CITY OF AUSTIN – DEVELOPMENT SERVICES DEPARTMENT
SITE PLAN APPLICATION – MASTER COMMENT REPORT

CASE NUMBER: SP-2018-0595C
REVISION #: 00
CASE MANAGER: Randall Rouda
UPDATE: U1
PHONE #: 512-974-3338

PROJECT NAME: 1303, 1311 & 1401 South Lamar
LOCATION: 1311 S LAMAR BLVD W/BLDGS & UNITS

SUBMITTAL DATE: March 20, 2019
REPORT DUE DATE: April 3, 2019
FINAL REPORT DATE: April 22, 2019
19 DAYS HAVE BEEN ADDED TO THE UPDATE DEADLINE

1-36	OSHA/TEXAS_SAFETY_CODE	
SHEET 1 OF 1	OVERHEAD_WORKING_CLEARANCES	
11/05/03	FROM_OVERHEAD_LINES_FOR_UNQUALIFIED_PERSONS	
		REV. 05/25/12

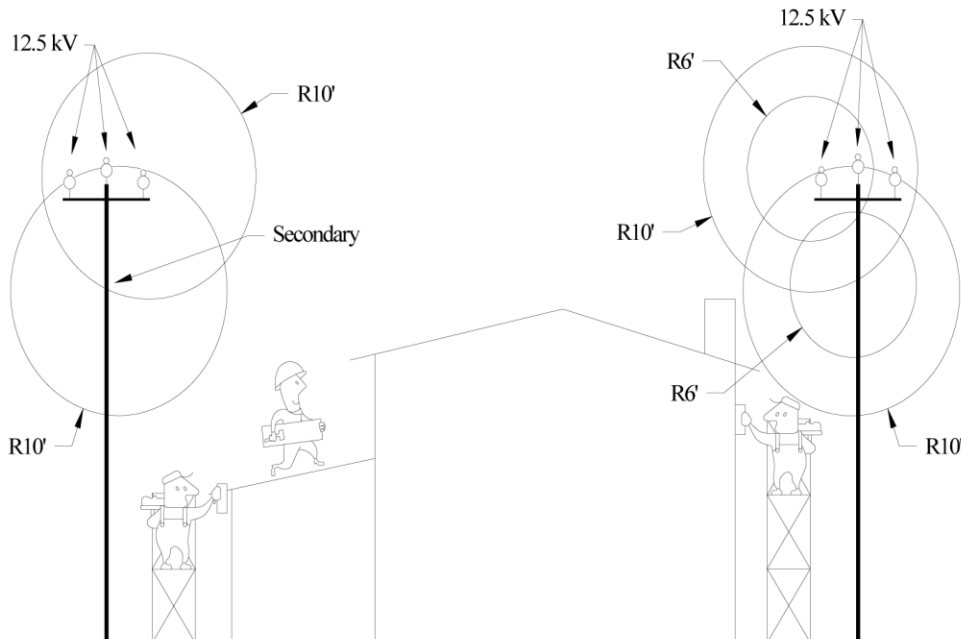
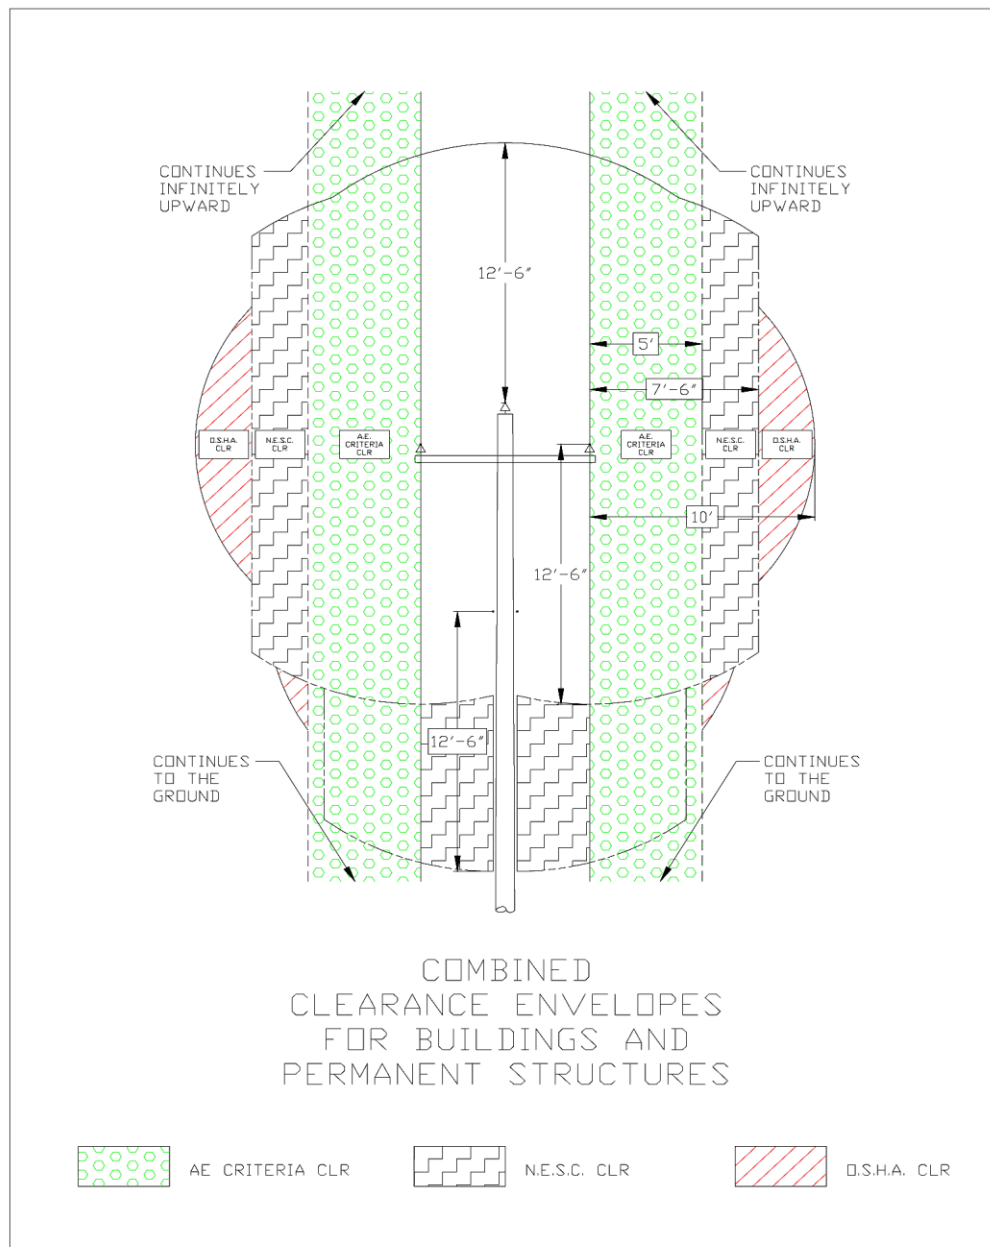
EL 1. The existing overhead facility on the north lot line must be cleared of the proposed building shown. This facility has 4 ft. cross arms from the center of the pole. The following must be shown and building relocated for safety and clearance per AE, NESC and OSHA requirements. A profile plan of each side of the proposed building including overhangs and balconies and the existing electrical pole include the height with all three conductors/neutral. Link of the criteria manual.

Update 1: It is understood the developer wishes to relocate those lines. Coordinate with the property owner to the north as well as Christian Pope, Christian.pope@austinenergy.com or ph. 512-505-7674.
